Addendum 109: Regulation No. 110

Revision 1 – Amendment 2

Supplement 9 to the original version of the Regulation: Date of entry into force:
19 August 2010

Uniform provisions concerning the approval of:

“Figure 2
 20 MPa Filling unit Size 2 (receptacle) for M₂, M₃, N₂ and N₃ vehicles

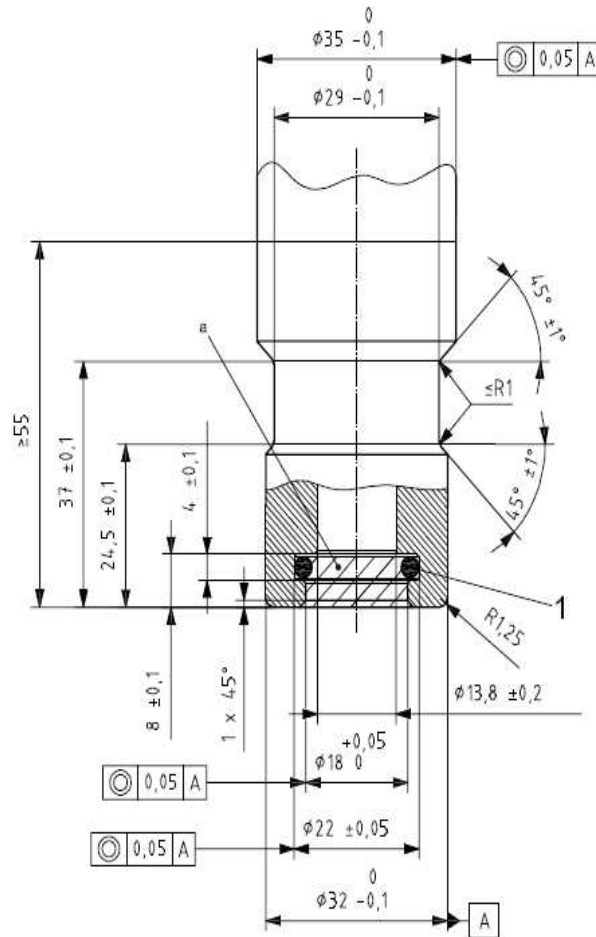
Insert a new paragraph 4.2., to read:

“4.2. Figure 2 shows the dimensions of the filling unit for vehicles of categories M₂, M₃, N₂ and N₃³”

Insert, after Figure 1, a new Figure 2, to read:

1 sealing ID = $\varnothing 15,47 \pm 0,1$ width = $\varnothing 3,53 \pm 0,2$

^a This area shall be kept free of all components

Surface roughness < Ra 3,2 μm .

Sealing surface finish: 0,8 μm to 0,05 μm .

Material hardness: 75 Rockwell B (HRB 75) minimum.
